UNITED STATES PATENT AND TRADEMARK OFFICE

APPLICATION NO.	FILING DATE	FIRST NAMED INVENTOR	ATTORNEY DOCKET NO.	CONFIRMATION NO.
10/815,993	04/02/2004	Gary W. Brondt	44948	7270

Office Action Summary

DETAILED ACTION

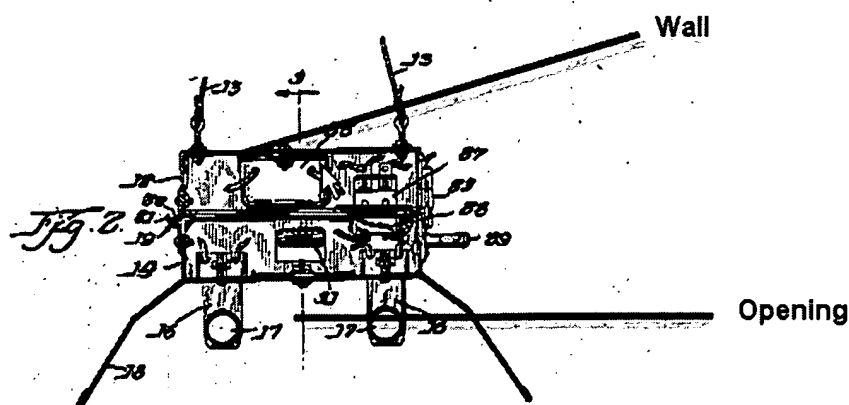
With respect to claims 1 and 2, Westby teaches a lighting fixture (fig 1), comprising a housing 12 supporting a first lamp 17 including a wall and an opening opposite the wall (drawn in below). Westby also teaches a first suspension cable 13 coupled with a housing. The cable includes opposite first and second ends (shown in Fig 1, not numbered) the first end of the suspension cable having a first loop. Westby fails to teach a tongue which engages the loop of a cable. Ambasz teaches a tongue 46, integrally formed with the wall of the housing, which engages a suspension cable. It would have been obvious for one of ordinary skill in the art to combine the tongue of Ambasz with the lighting fixture of Westby in order to provide a simpler device with fewer parts to suspend the lighting fixture from a support.

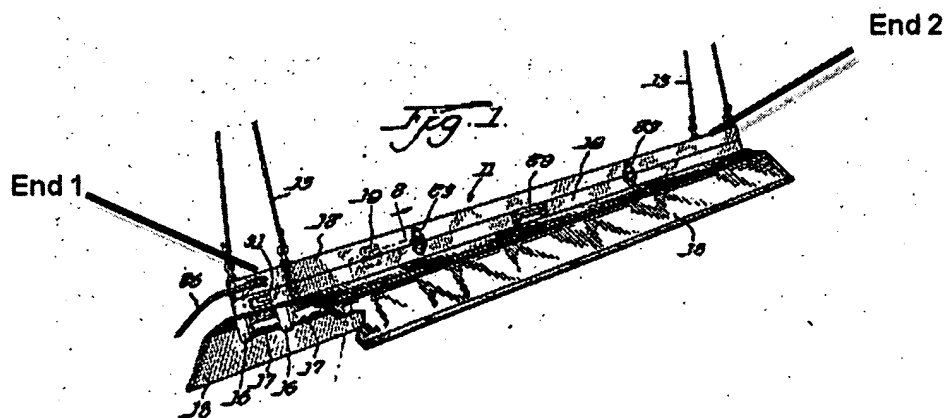
As for claim 3, Westby and Ambasz teach the lighting fixture of claim 1, Ambasz teaches a second tongue 46 (not visible in the device because of the angle of the drawing), and a second suspension cable 48 includes a third end (drawn in below) with a second loop (end 3 makes up the second loop) engaging the tongue. It would have been obvious for one of ordinary skill in the art to combine the tongues and suspension cable arrangement of Ambasz with the lighting fixture of Westby in order to be able to hang the device from a support using less cables than Westby's support structure, which requires less materials and makes it less expensive.

As for claim 4, Westby and Ambasz teach the lighting fixture as discussed above, wherein the wall of the housing includes opposing ends (drawn below) and the first tongue 46 is disposed adjacent to one of the ends. Westby discloses attachment devices for the cables, at each end, but does not teach tongues. See the discussion in regard to claim 1 for the tongues.
